Technical Service BULLETIN

VSC COMPUTER LOGIC MODIFICATION FOR DTC C1231

'03 Sequoia

BR003-03 BRAKES

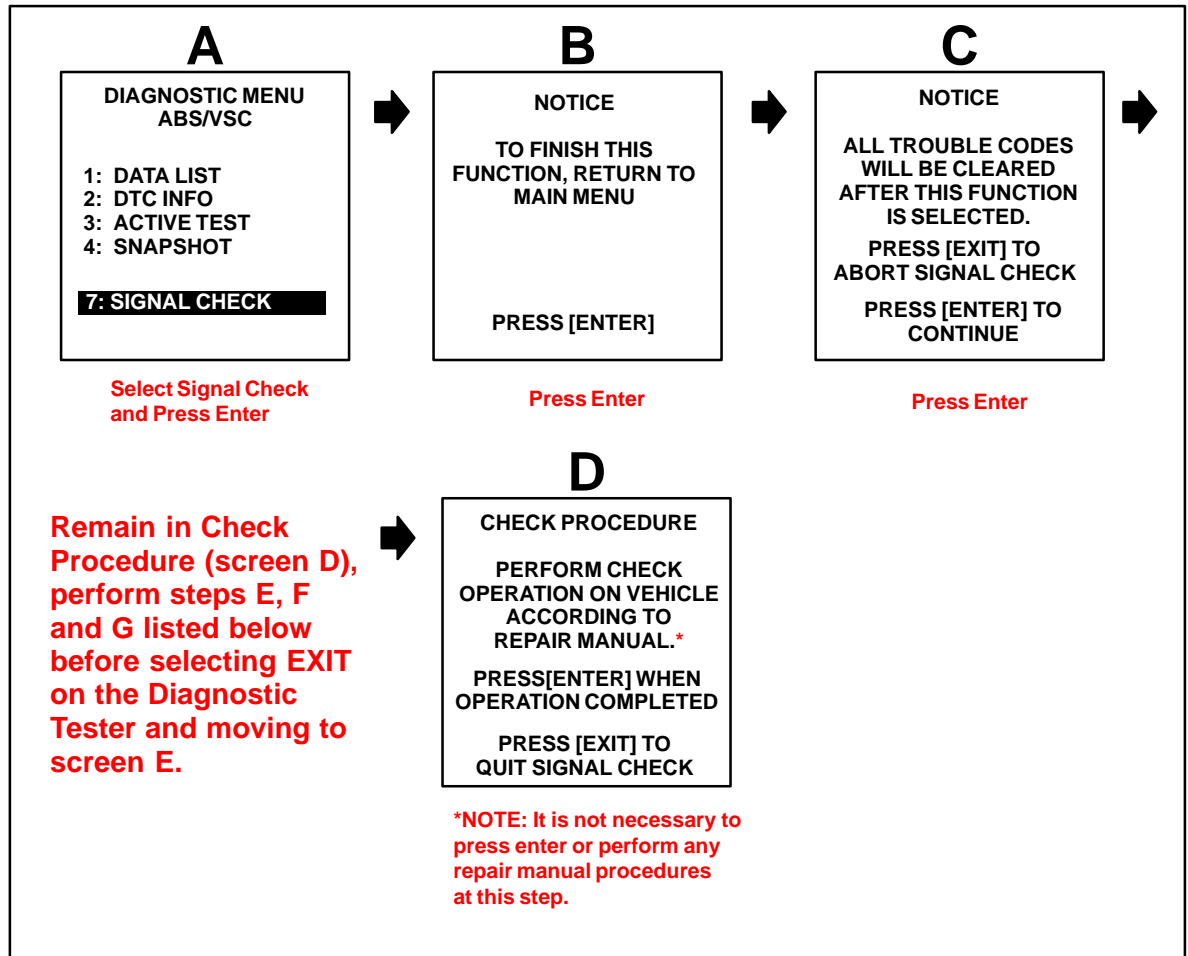
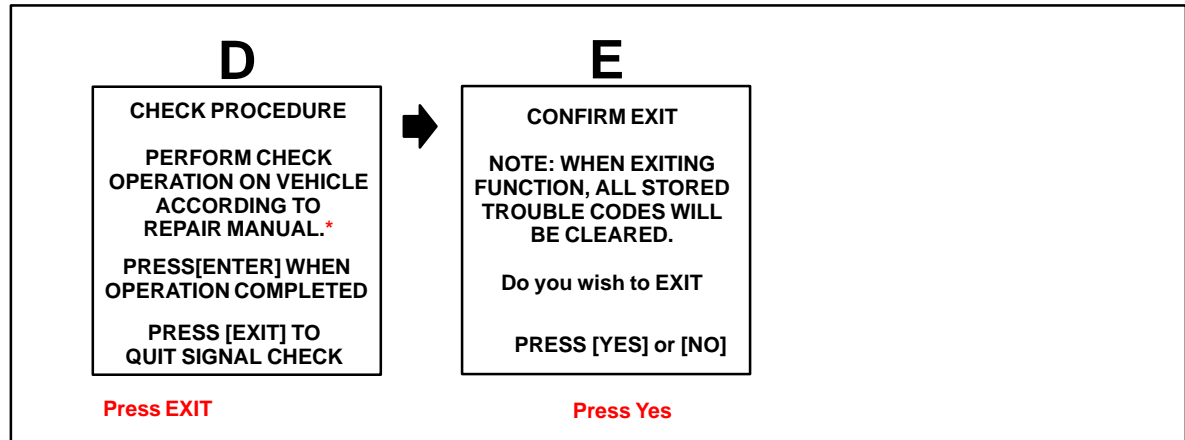
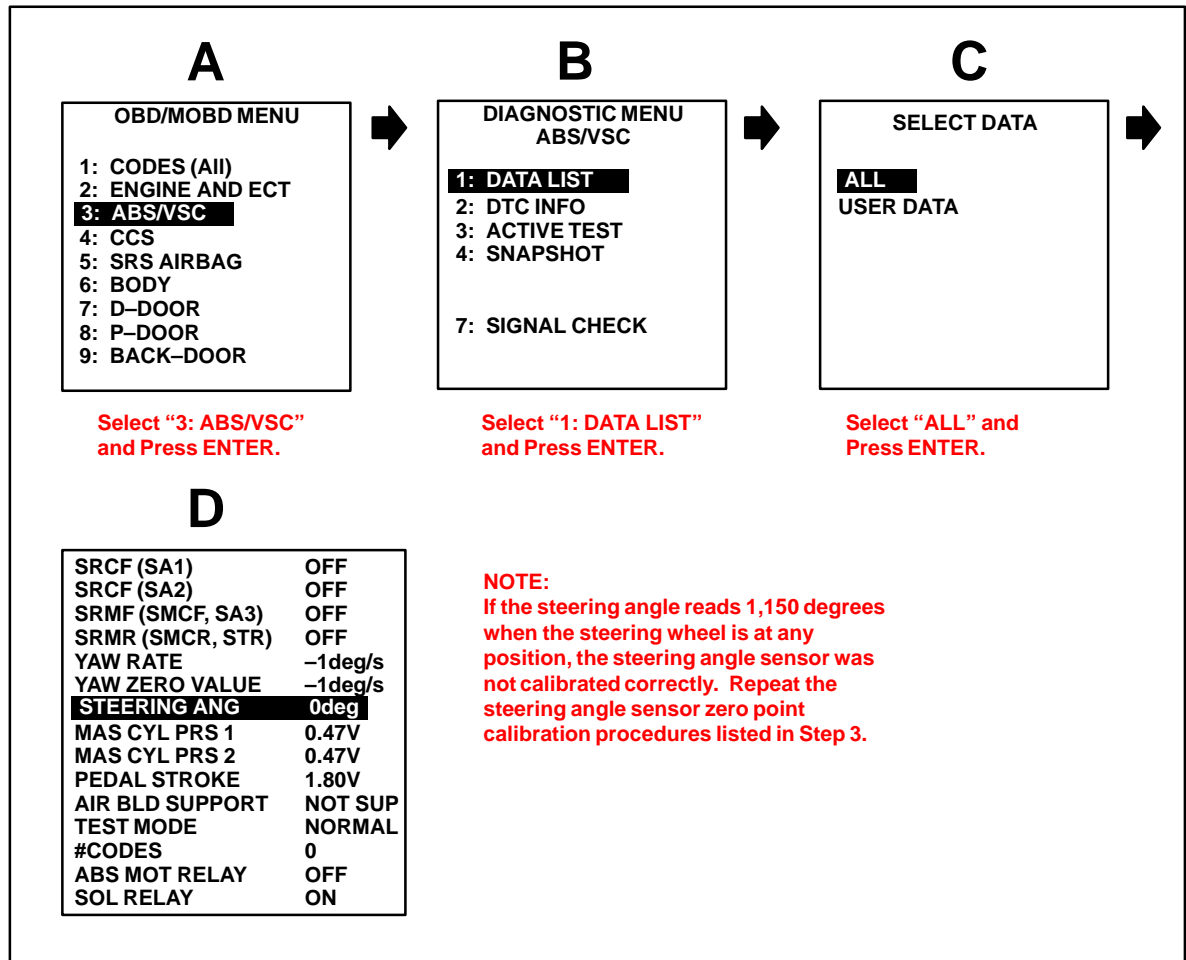
May 13, 2004: The Diagnostic Tester screen flows on pages 3 – 5 have been changed. All previous versions of this TSB should be discarded.
